**SERVICE KIT: #59**

**EFFECTIVITY:** All AT-802 aircraft with Wipline 10000 Floats

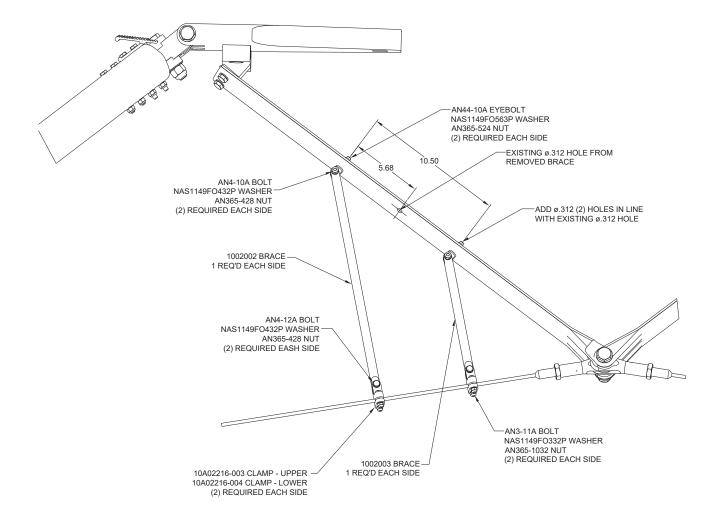
**BACKGROUND INFORMATION:** Unsymmetrical loads when taking off or landing will cause the upper forward flat strut to distort.

NOTE: If strut has been distorted by the asymmetrical loads, return it to straight before moving on to Step 2. (This straightening could have been done up to and including 7 times before this strut needs to be replaced.)

- 1. Remove existing brace and hardware.
- 2. Measure and mark the 2 new holes as per the included sketch.
- 3. Drill both holes on either side of the aircraft strut with .312 inch holes. Corrosion proof the bare metal with primer and paint.
- 4. Add the eyebolts to the strut on either side and streamline the fly wires.
- 5. Attach the braces to the eyebolts and fly wire clamps. Position approximately as shown and tighten all hardware.
